ADDENDUM NO. 1

SEPTEMBER 17, 2024

- A. Project Name: BALL STATE HONORS HOUSE ADDITION
- B. Owner: Ball State University
- C. Owner Project Number: 2024-009.01 BA
- D. Architect: arcDESIGN
- E. Architect Project Number: 24118

SITE LOGISTIC PLAN

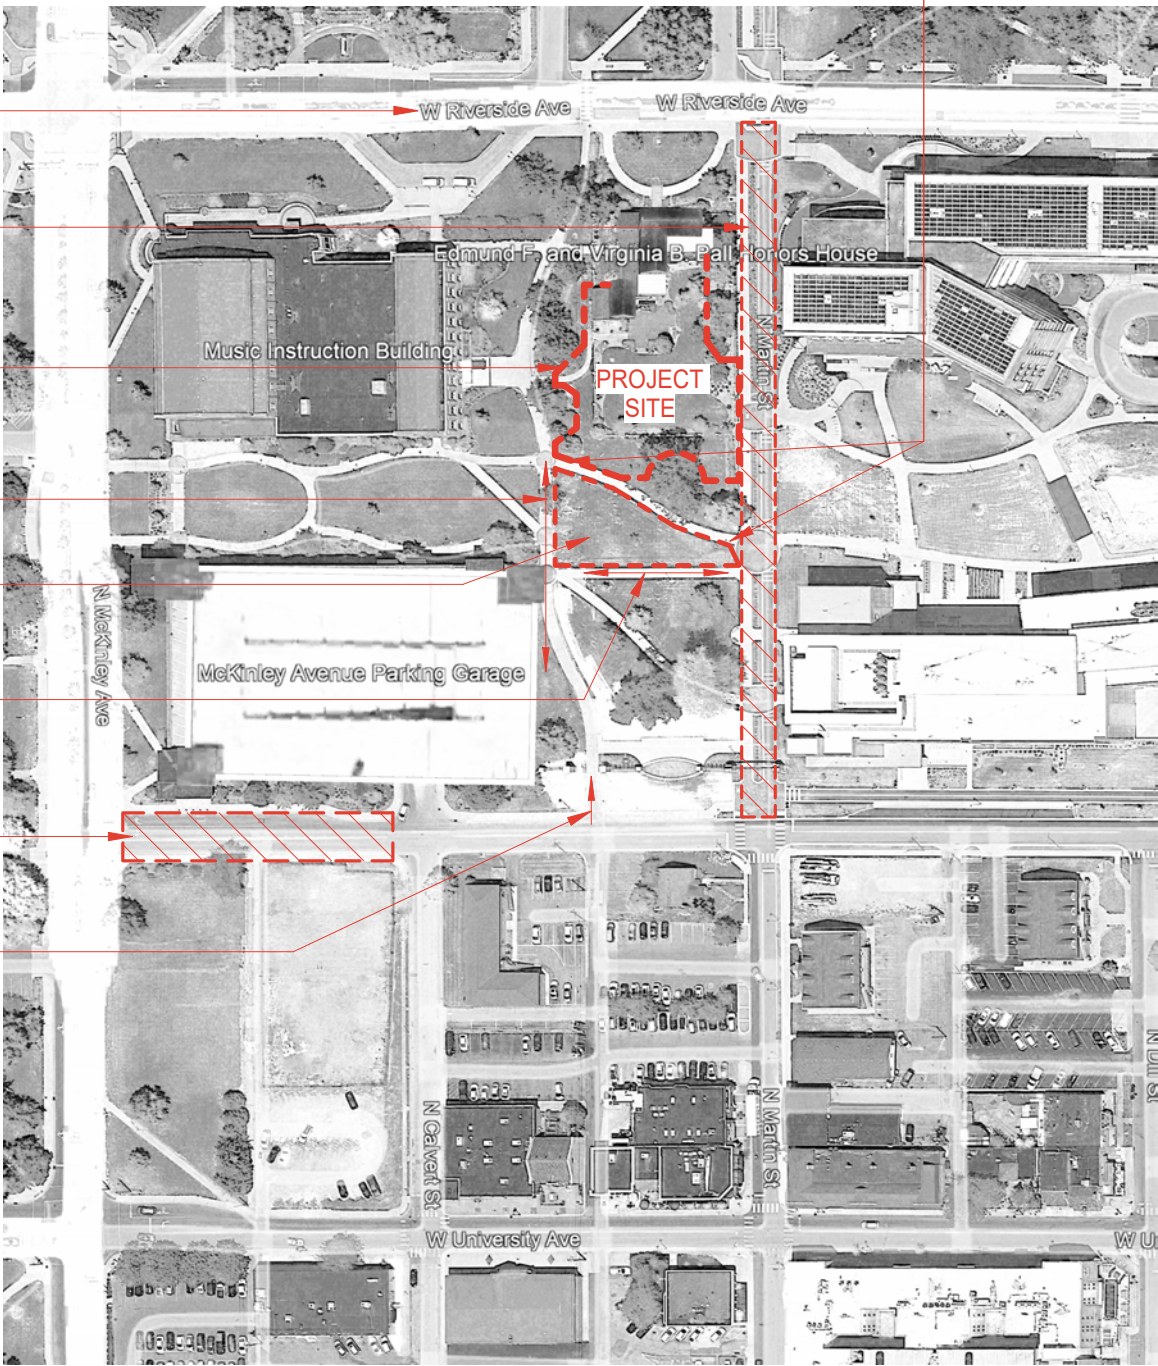
- A. See the attached "Site Logistics Plan" for general information on site access and location.

- C. (Pre-Bid Meeting) Are there site access restrictions?
 - 1. Yes, the only access will be off Ashland Avenue (south). No construction traffic will be allowed on the Martin Street pedestrian corridor. The G.C. will be responsible for protecting all site items and returning them to their existing condition or better at the end of the project. arcDESIGN will work with Ball State to develop a site logistics plan to issue (included in this Addendum).

CONTRACTOR OPTION: PORTION OF
SIDEWALK BETWEEN SITE AND LAYDOWN
MAY BE CLOSED DOWN IF IT HELPS SITE
ACCESS AND COST. COORDINATE TREE
PROTECTION WITH OWNER.

- NO CONSTRUCTION
ACCESS FROM
W RIVERSIDE AVE
- THERE IS TO BE NO
CONSTRUCTION ACTIVITY
OR VEHICULAR TRAFFIC
ALONG THE MARTIN
STREET PATHWAY
- CONSTRUCTION FENCE,
REF. L-SERIES
- NORTH/SOUTH
PEDESTRIAN ACCESS
MUST BE MAINTAINED
- OPTIONAL ADDITIONAL
LAYDOWN AREA
- EAST/WEST PEDESTRIAN
ACCESS MUST BE
MAINTAINED
- PORTION OF ASHLAND
STREET CLOSED, NO
ACCESS
- CONSTRUCTION ACCESS
HERE. G.C. SHALL
PROTECT PATH TO SITE
FROM DAMAGE,
INCLUDING BUT NOT
LIMITED TO LAWNS,
PLANTINGS, SIDEWALKS,
PAVEMENTS, CURBS,
AND UNDERGROUND
STRUCTURES AND
RETURN TO MATCH
EXISTING CONDITIONS
AT THE END OF THE
PROJECT.

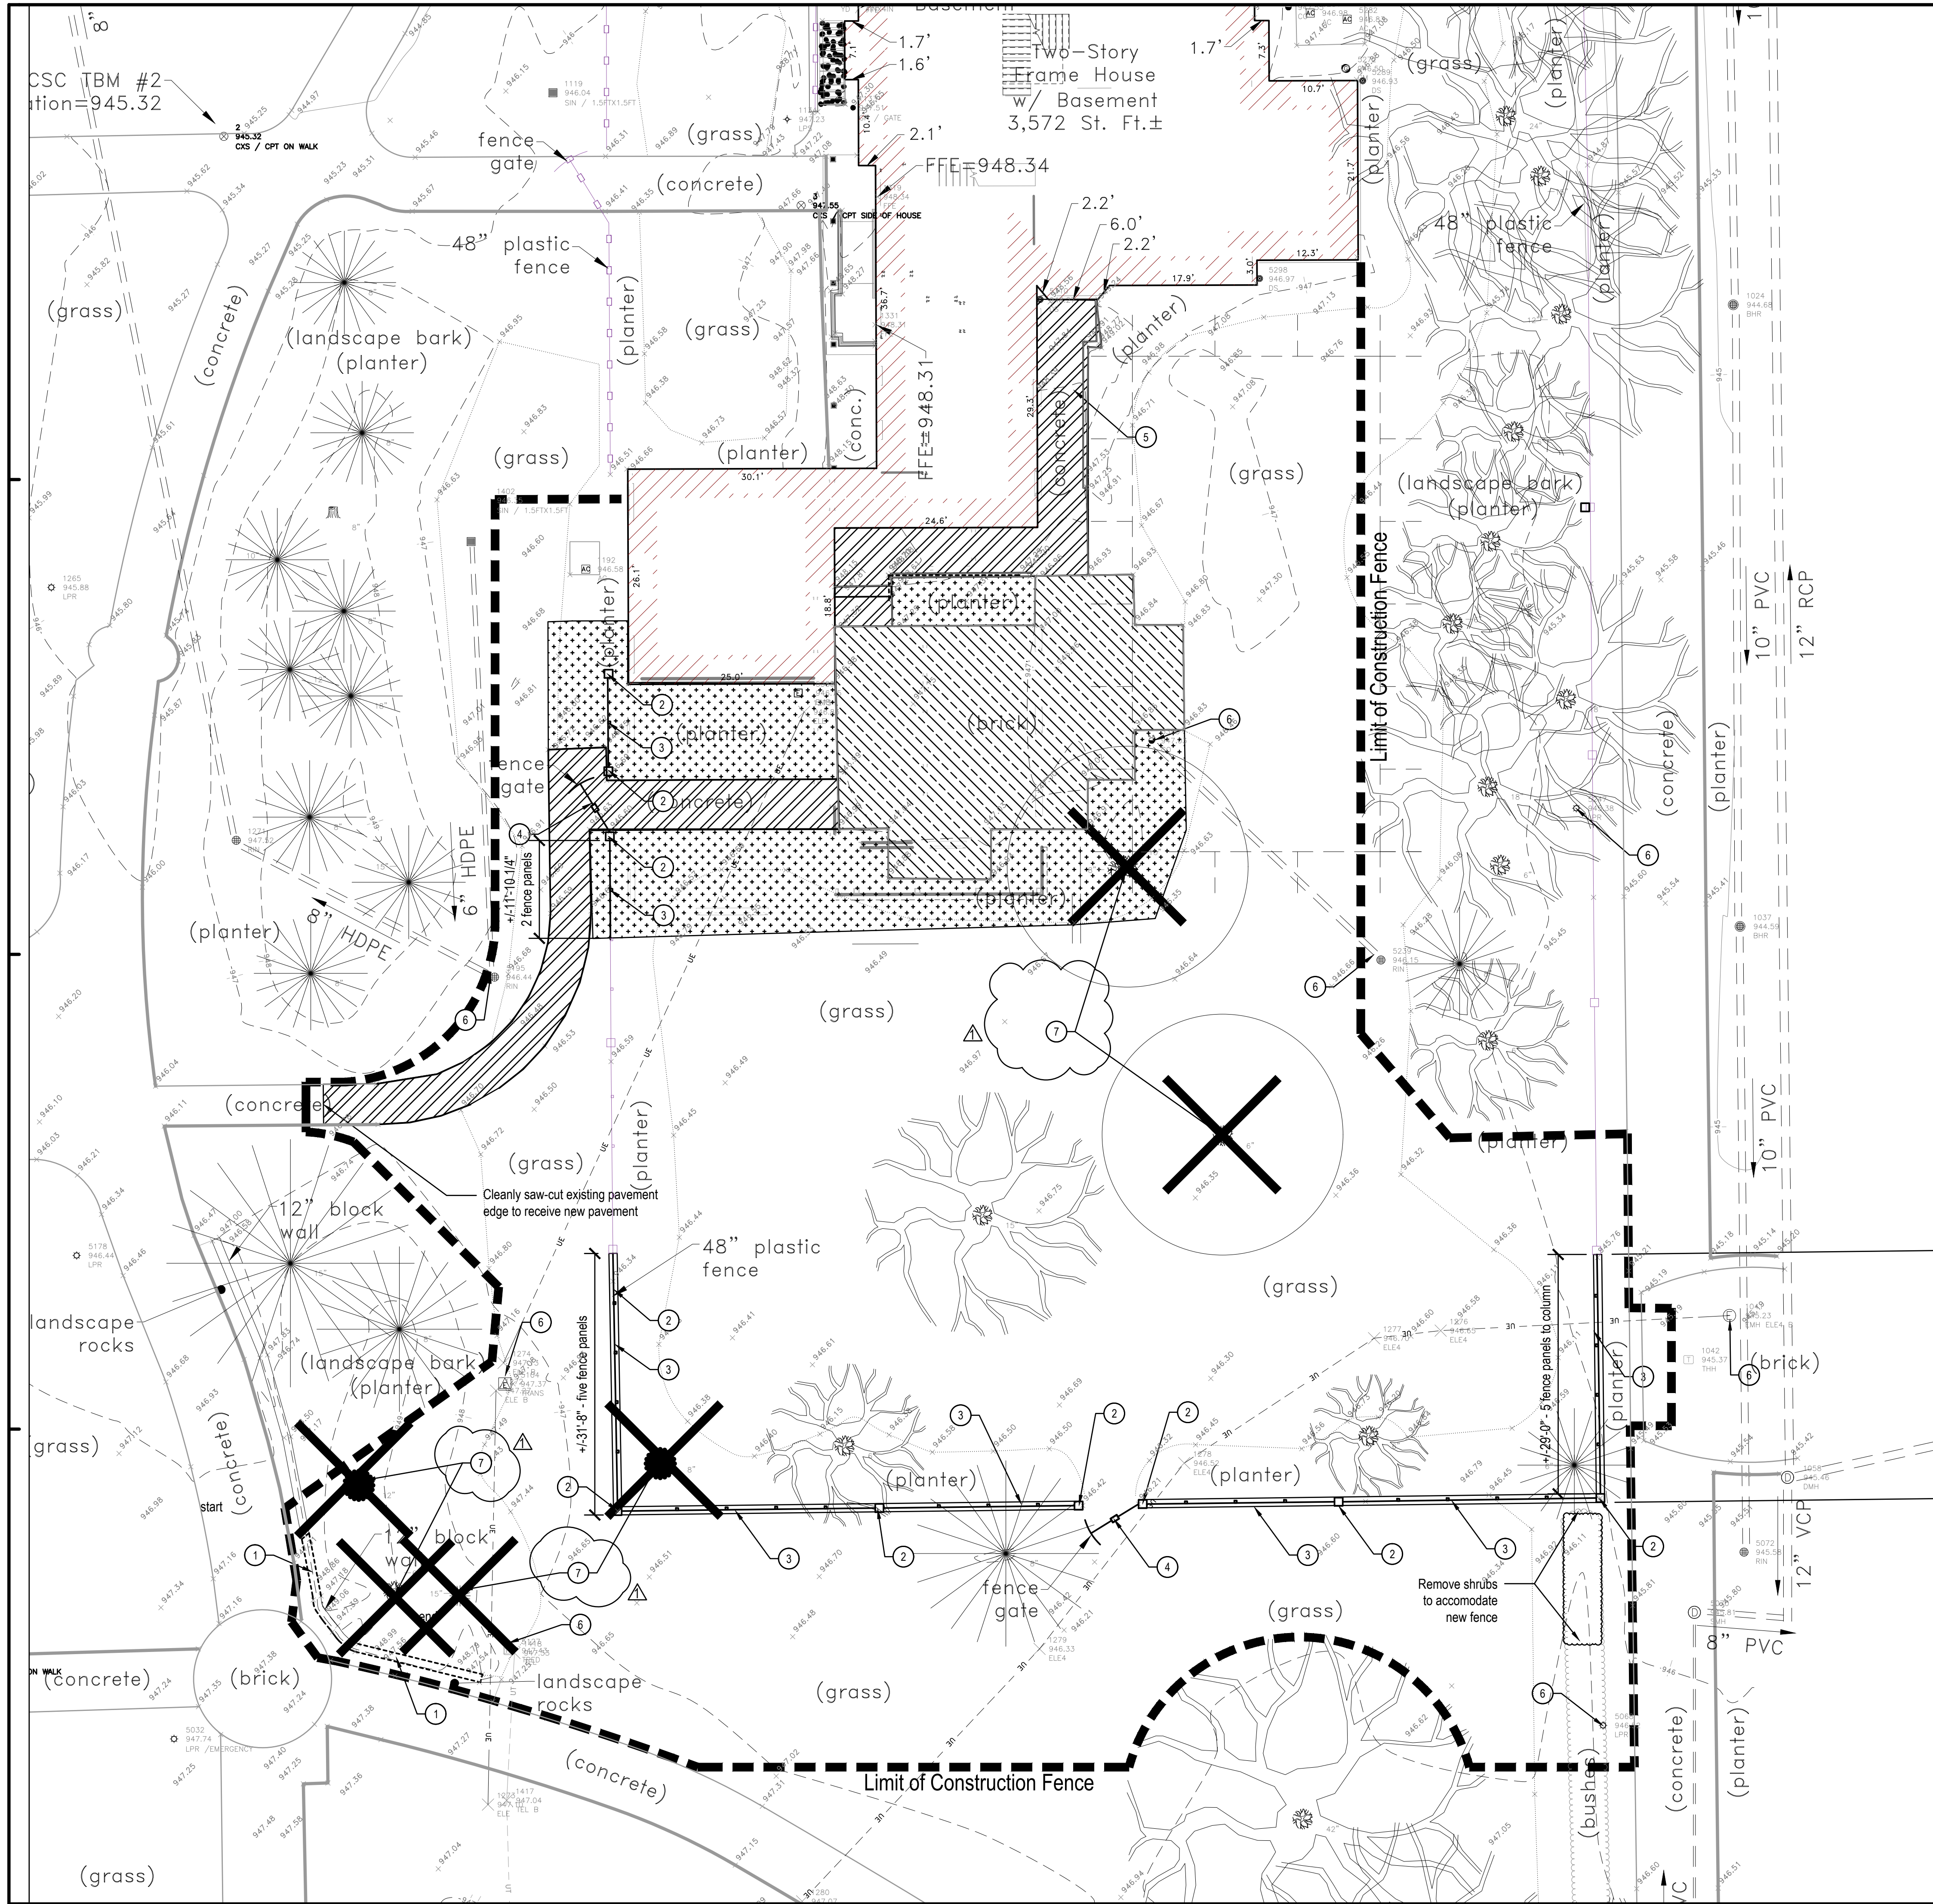
- A. 00 10 00 – TABLE OF CONTENTS
 - 1. Add "00 91 13 ADDENDUM NO. 1"
- B. 00 91 13 – ADDENDUM NO. 1
 - 1. Add Section 00 91 13 ADDENDUM NO. 1 (this document) to the project manual in its entirety.
- C. 01 56 39 – TREE PROTECTION PLAN
 - 1. Remove Article 1.2 Paragraph B in its entirety, see attached revised Specification.

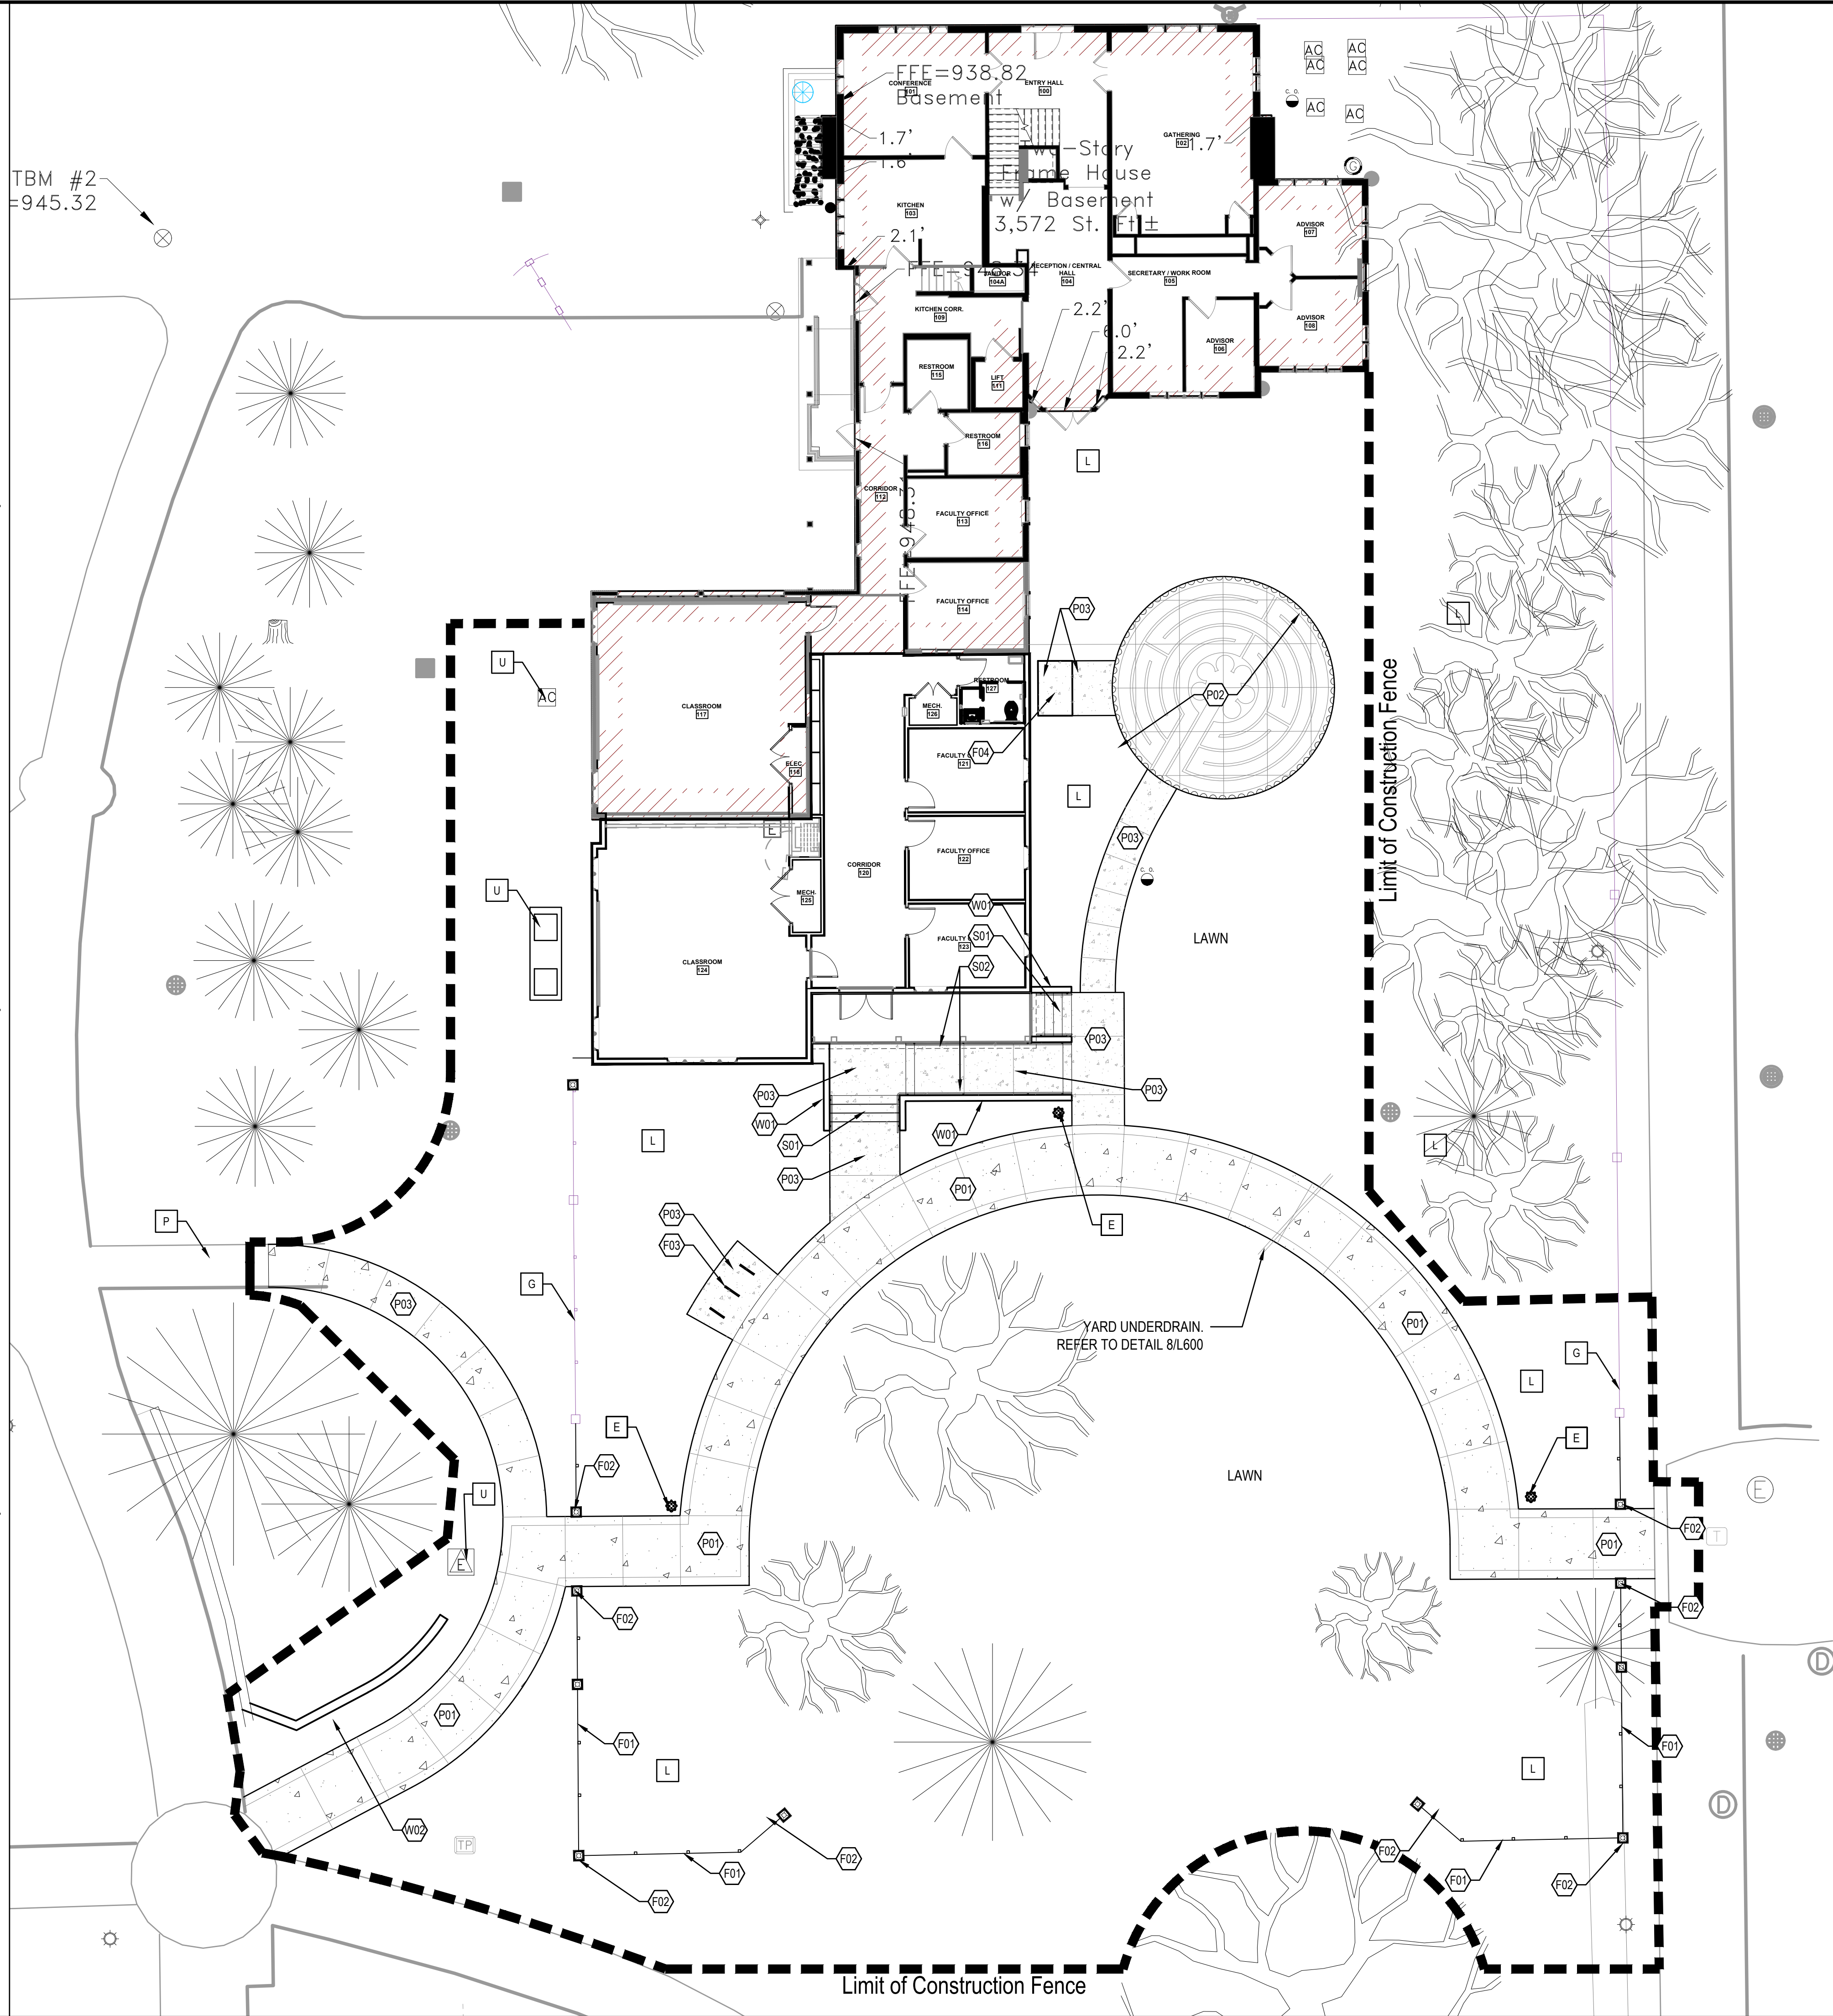
- A. Sheet L002 – SITE DEMOLITION PLAN
 - 1. Revise note 3 as indicated on the attached revised Sheet.
 - 2. Revise notes for tree stump removal as indicated on the attached revised Sheet.
- B. Sheet L100 – SITE MATERIALS PLAN
 - 1. Revise Material Keynote note "P02" as indicated on the attached revised Sheet.

- Pavers and subbase to be removed completely.
- Concrete and subbase to be removed completely.
- Planting Bed and trellis to be removed.
- Tree and stump to be removed completely.
